CITY OF TACOMA
Department of Public Utilities – Tacoma Power

ADDENDUM NO. 2

REVISIONS TO:
Request for Proposals Specification No. PG15-0519F
Tacoma Power Warehouse Community Solar

WAREHOUSE POWER RISER DIAGRAM
NTS

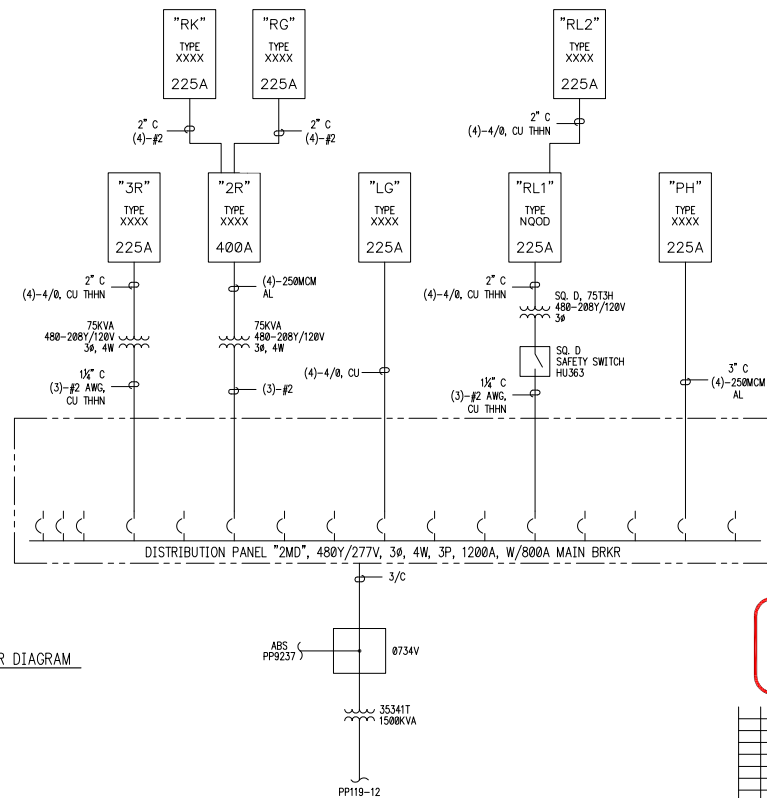
Replace Exhibit A Tacoma Power Site Survey Appendix F Drawing No. PP6003 with revised drawing: *clarified tie-in point for Phase 1 and Phase 2.*
